Pulaski County Schools
Energy Savings and Performance Contract
Addendum #2
March 25th, 2022

CMTA Contact:	Megan Brangers
Email:	MBrangers@cmta.com
Cell Phone:	502-919-1521

The following information supersedes or is in addition to information released in the Contract Documents dated March 11th, 2022 and addendum 1 dated March 18th, 2022.

ENLARGED MECHANICAL MEZZANINE
AIR DISTRIBUTION NEW WORK
SCALE: 1/4" = 1'-0"
2
M2-5.1

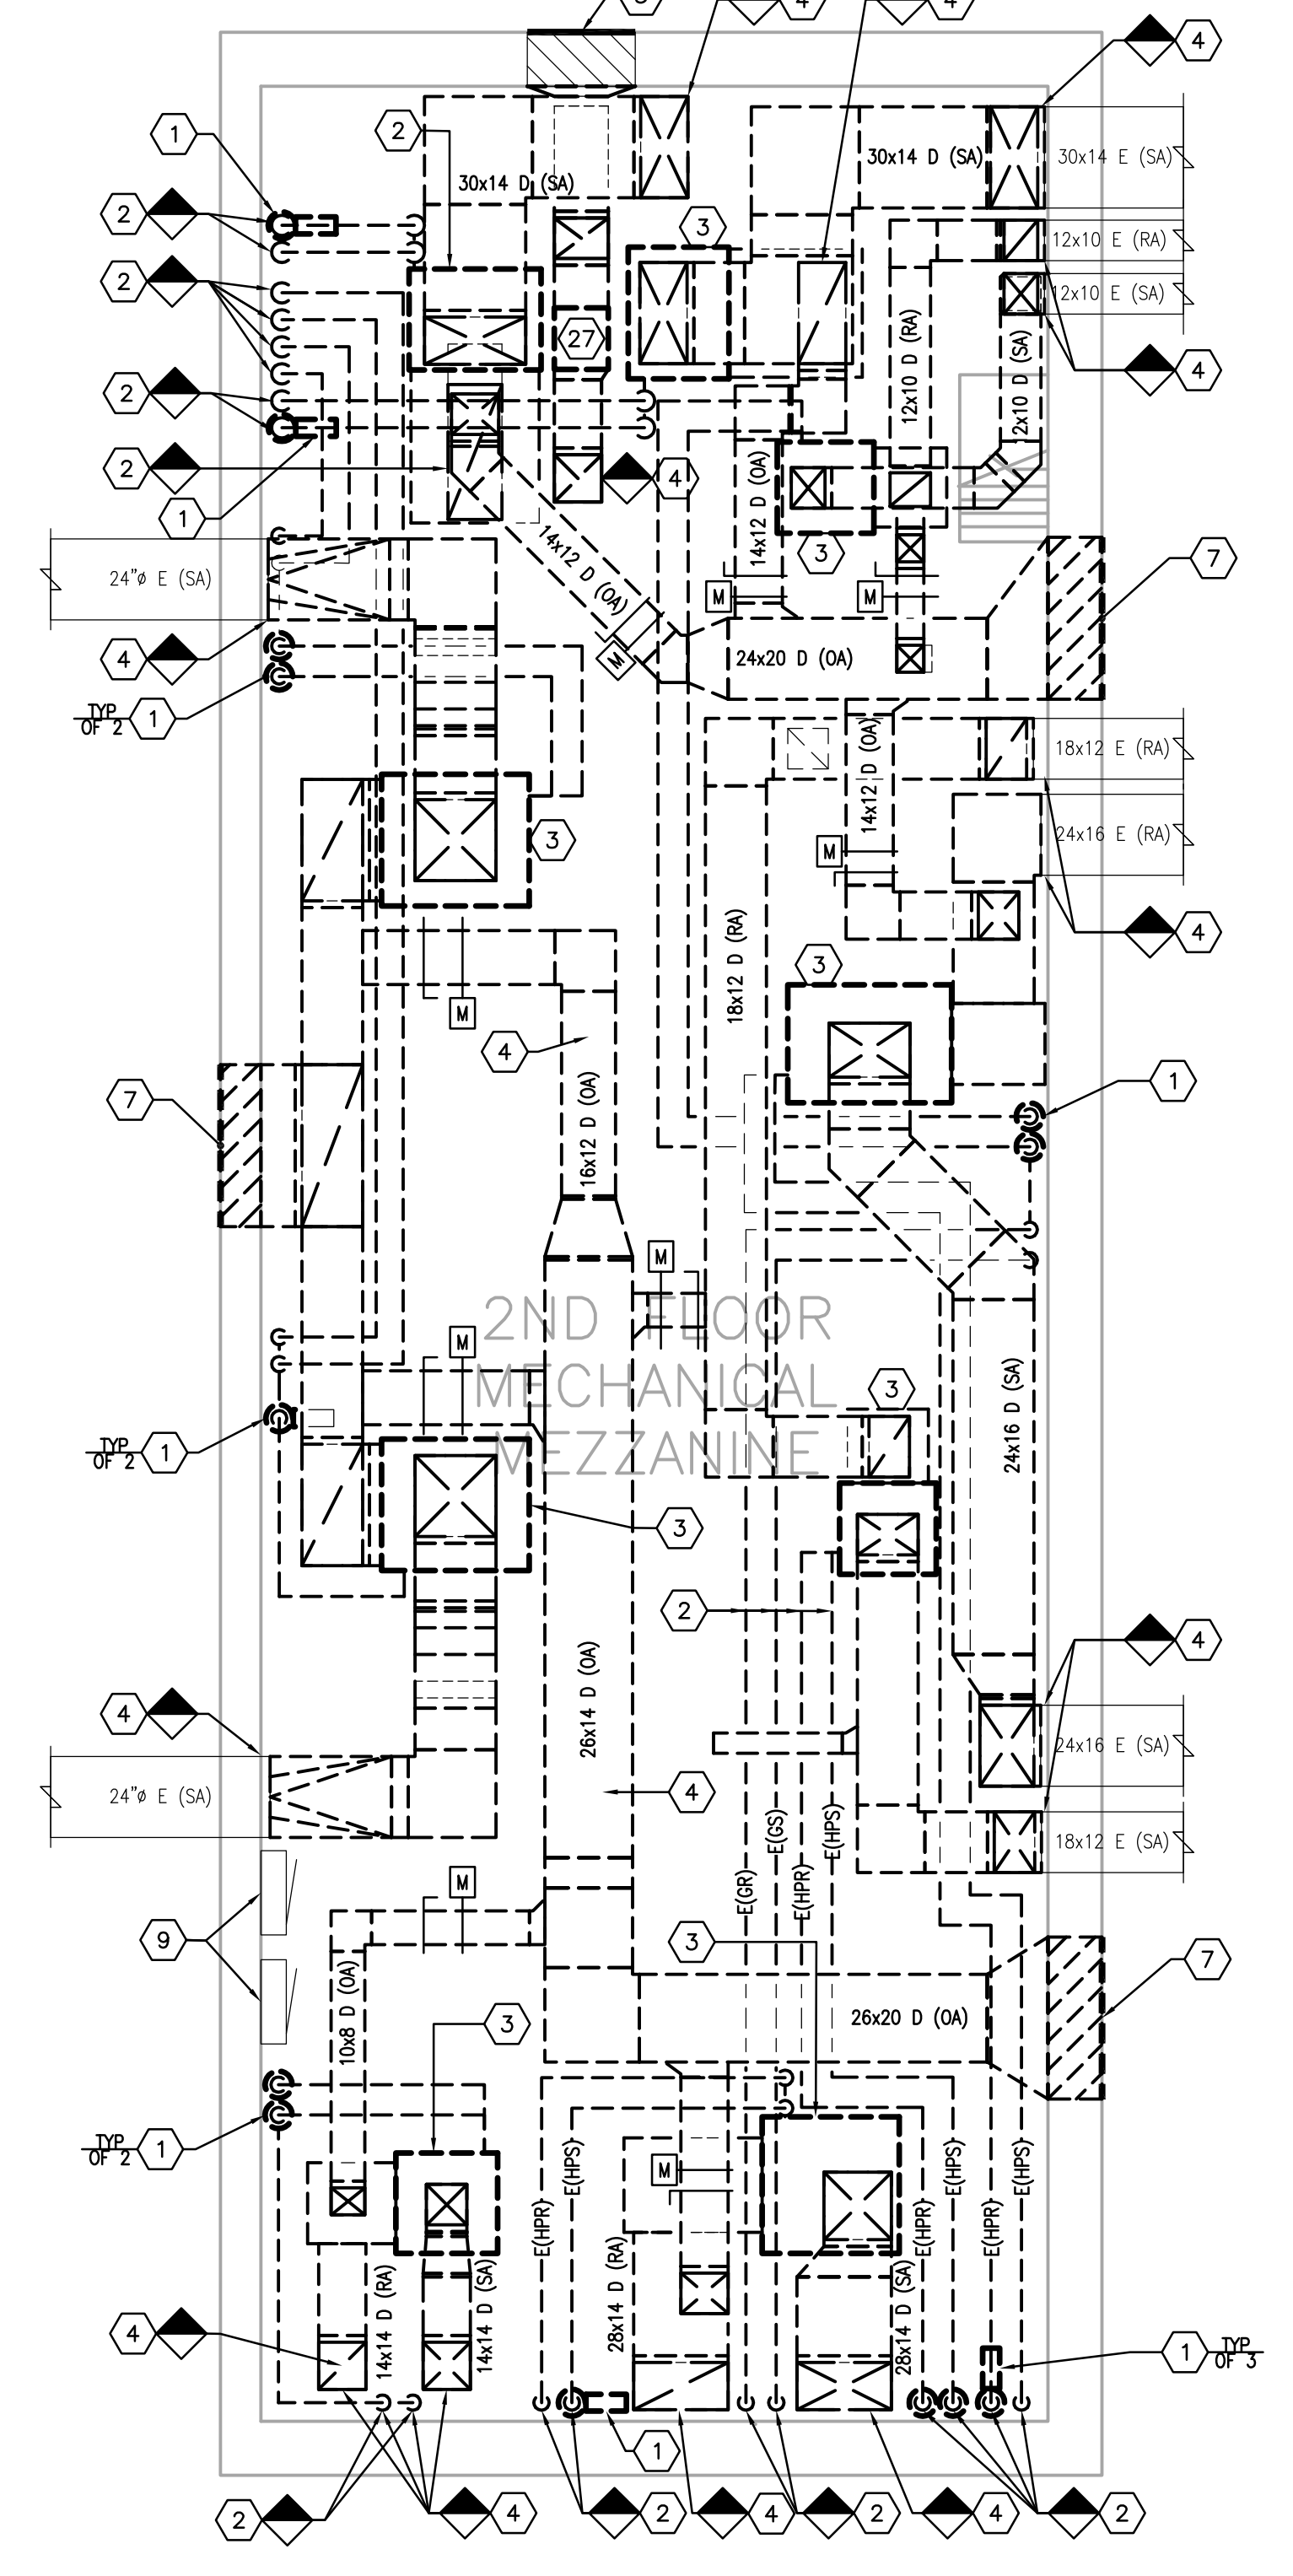
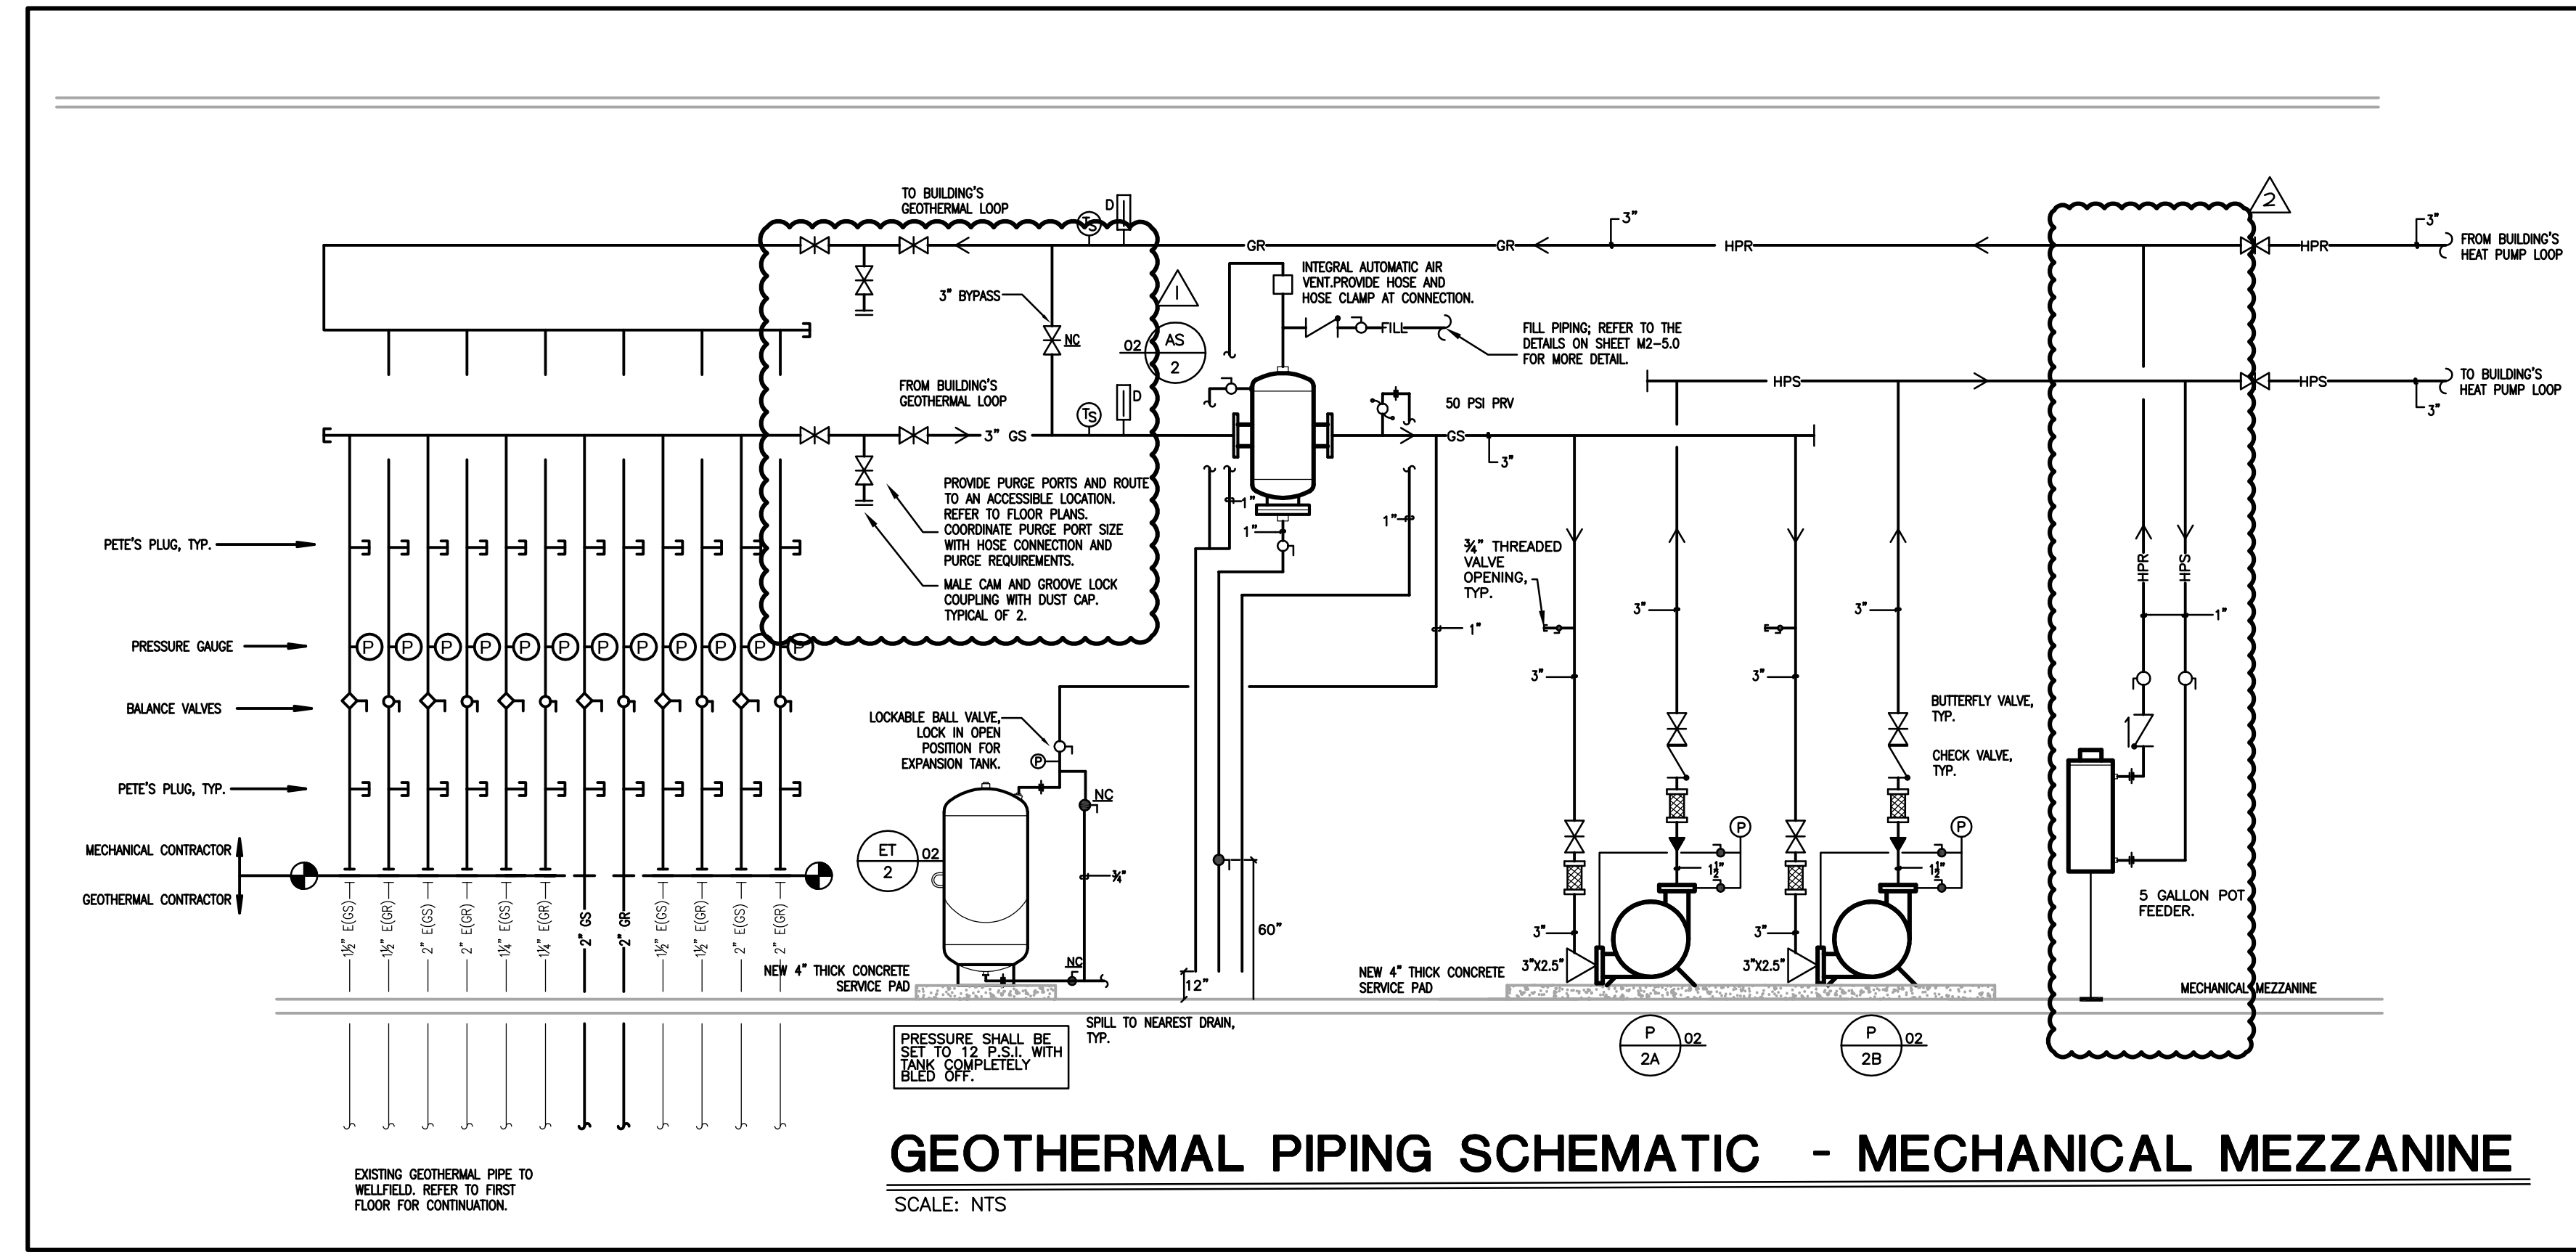
15. Drawing M2-5.1

- a. Refer to Mechanical Mezzanine Hydronics for revised geothermal and heat pump piping. Add geothermal wellfield bypass and purge ports. Add 5-gallon pot feeder.
- b. Refer to 'Geothermal Piping Schematic - Mechanical Mezzanine' for updates. Add geothermal wellfield bypass and purge ports. Add 5-gallon pot feeder.
